SAVANNAH PLACE ADDITION

RE: SUB 2000-82 -- One-Step Final Plat of SAVANNAH PLACE ADDITION

At the regular meeting of the Subdivision Committee of the Metropolitan Area Planning Commission on Thursday, October 12, 2000, the above captioned plat was considered. The action of the Committee was to approve the final plat, subject to the following:

STAFF REPORT
(One-Step Final Plat Approved 10/12/00)

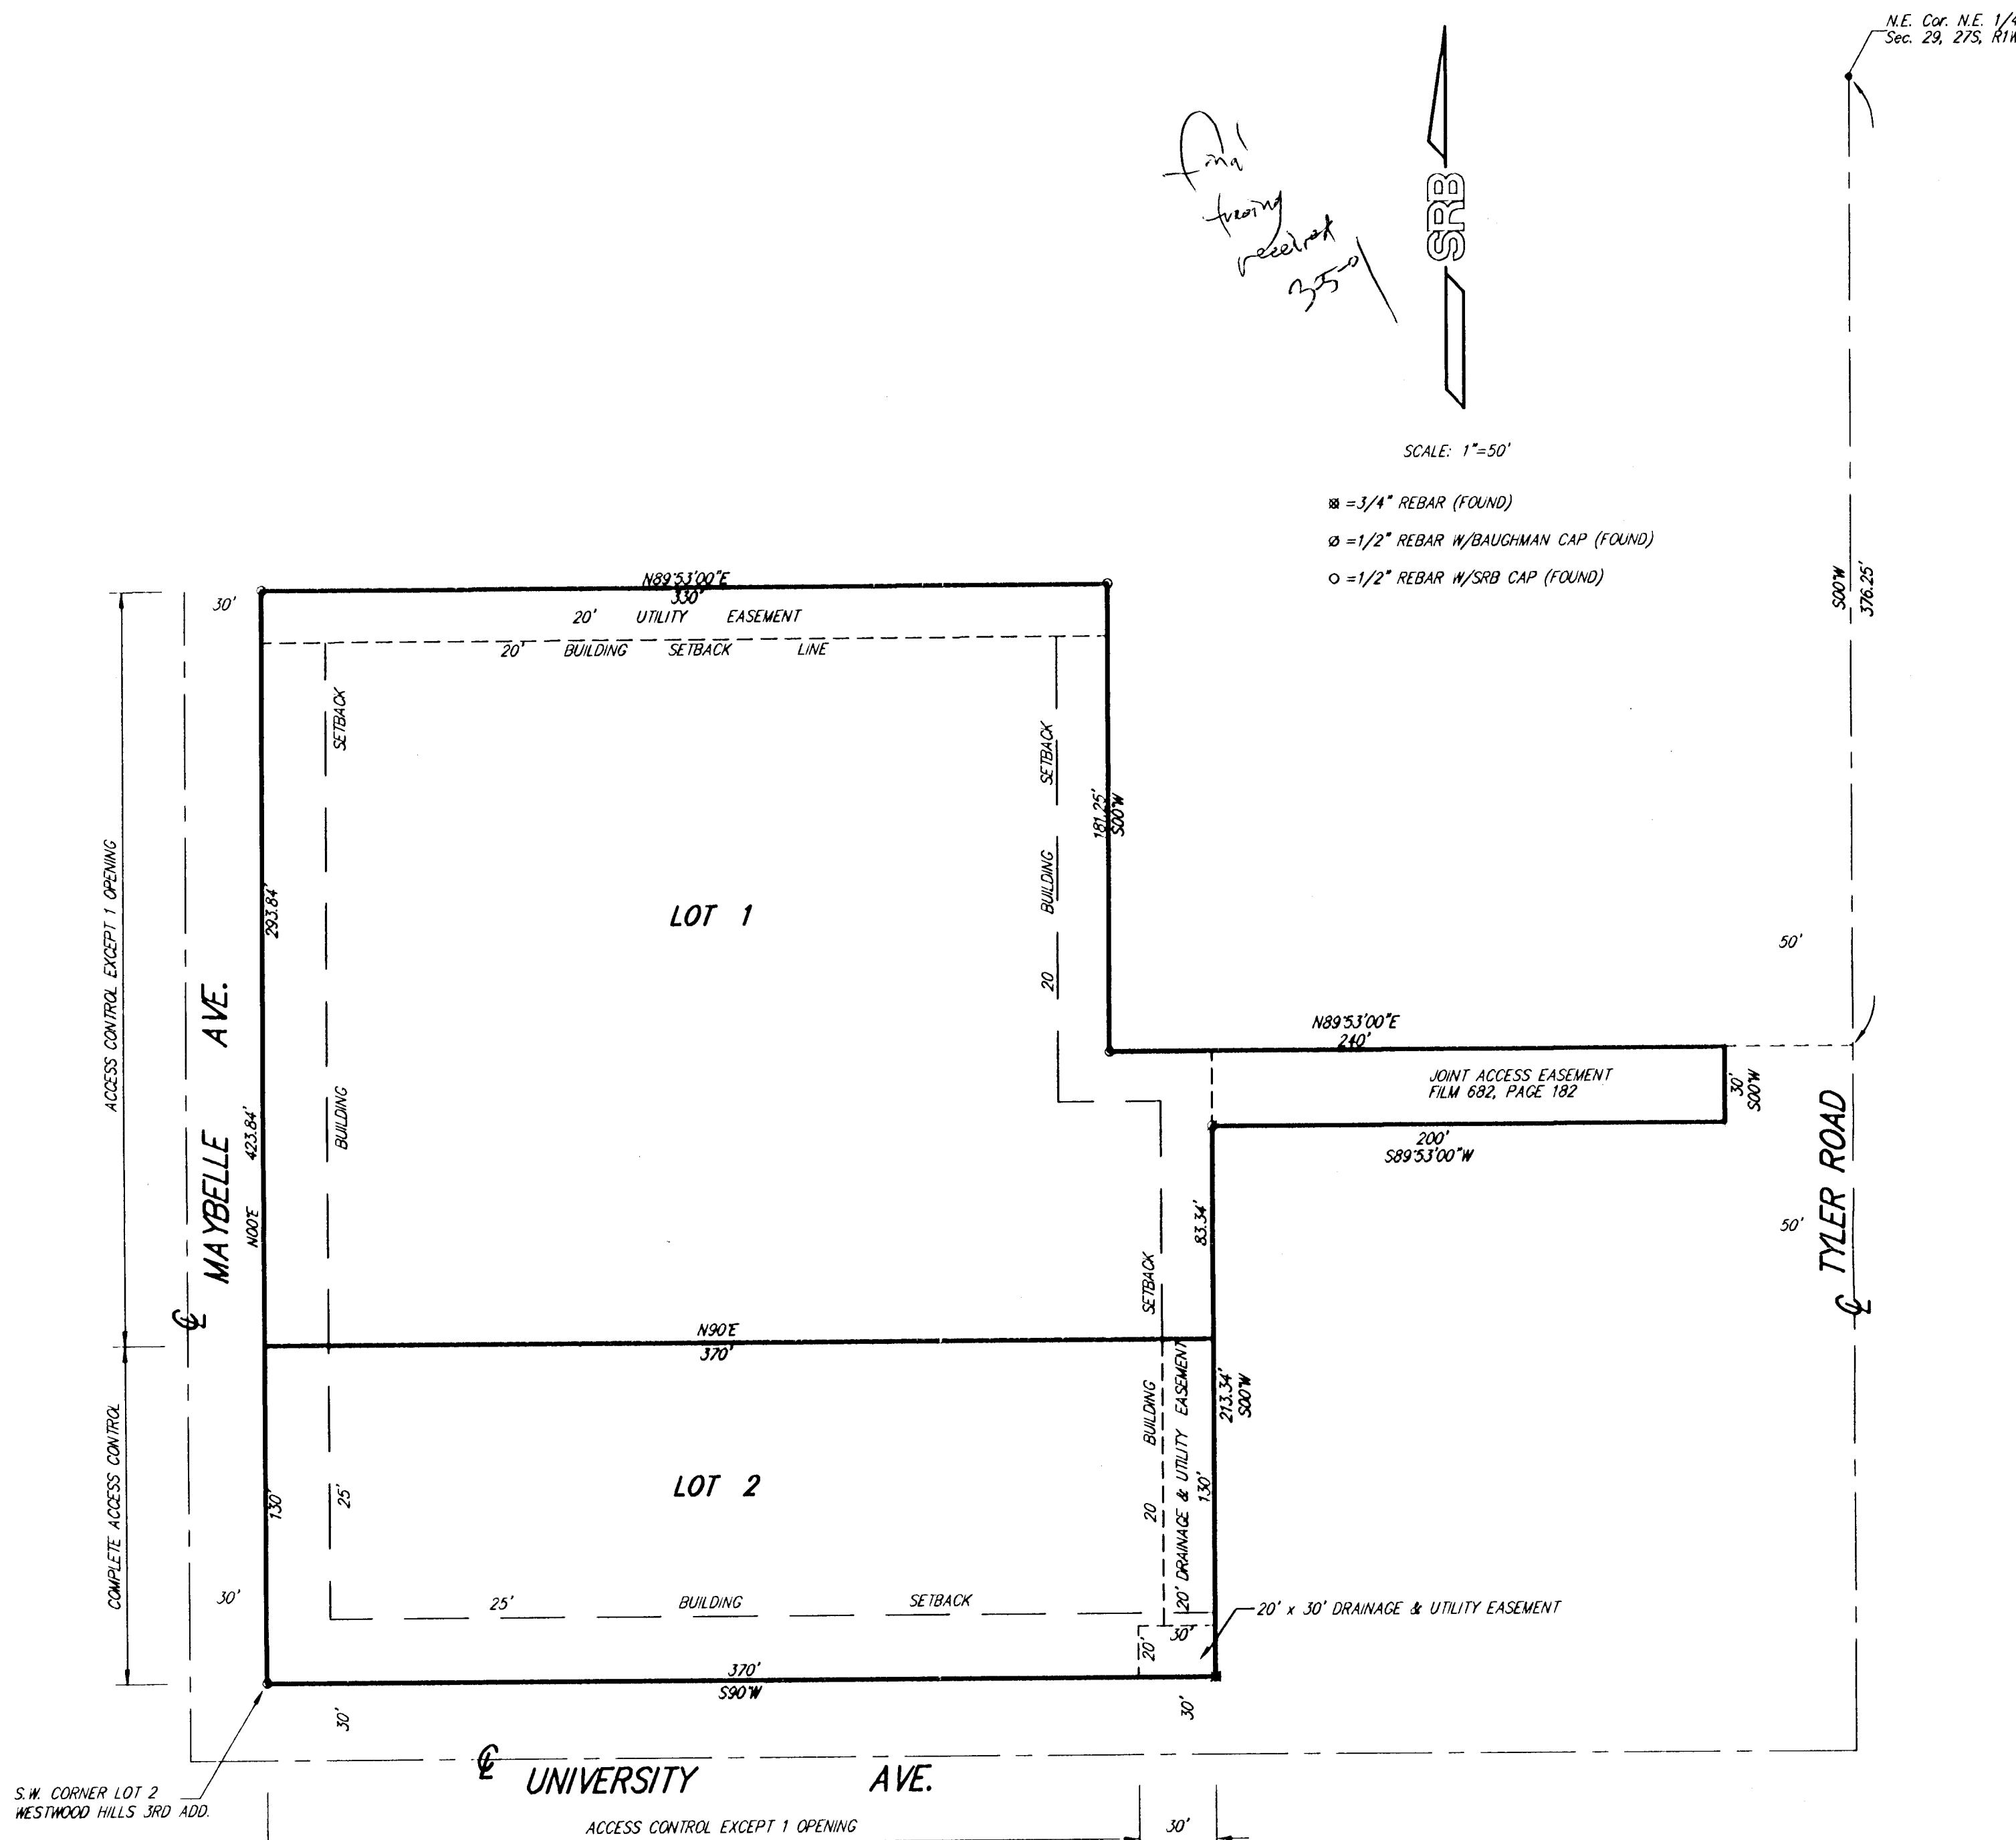
- A. City Engineering has previously obtained petitions for City water and sanitary sewer with the Westwood Hills 3rd Addition. City Engineering needs to comment on the need for any additional guarantees or easements. City Engineering has requested revised petitions.

- C. City Engineering needs to comment on the status of the applicant's drainage plan. City Engineering has approved the drainage plan.
- D. A CUP administrative adjustment will need to be obtained regarding the revised setbacks and access controls.

- F. As required by the sidewalk ordinance, sidewalks shall be provided along University Avenue and Maybelle Avenue. A sidewalk certificate was previously obtained with the Westwood Hills 3rd Addition.

- G. The platlor's text shall include language that a drainage plan has been developed for the plat and that all drainage easements, rights-of-way, or reserves shall remain at established grades or as modified with the approval of the applicable City or County Engineer, and unobstructed to allow for the conveyance of stormwater.

- Q. *The applicant will be adjusting the interior lot line to the south 50 feet. The final plat tracing shall reflect this revision.*

- Q. *The applicant will be adjusting the interior lot line to the south 50 feet. The final plat tracing shall reflect this revision.*
